Release Date	06/22/2023	<b>Technical Service Bulletin</b>	
<b>51H9 UPDATE</b> <b>Sealing Underbody – (NVLW)</b>			 <b>Audi</b>

<b>This Update has been proactively released to prevent the following condition(s) from occurring in the vehicle:</b>	
Criteria	Technical Background
ALL	The paint drain hole on the front left of the underbody was not sealed due to a change in components. As a result, water may enter the vehicle interior at the front left through this paint drain hole.

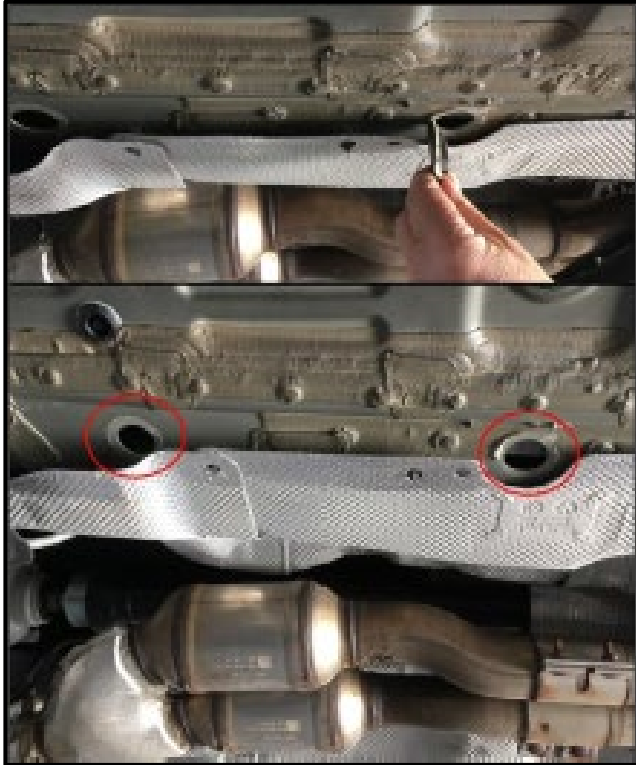
- Clean drain hole with cleaning solution and reinsert plug that was removed previously.

- Clean drain holes with cleaning solution.
- Reinsert all plugs with adhesive sealant (D -511-500-A2 OR D -476-KD2-M2) and spread out excess material.
- Reinstall underbody trim panel in the reverse order of removal.
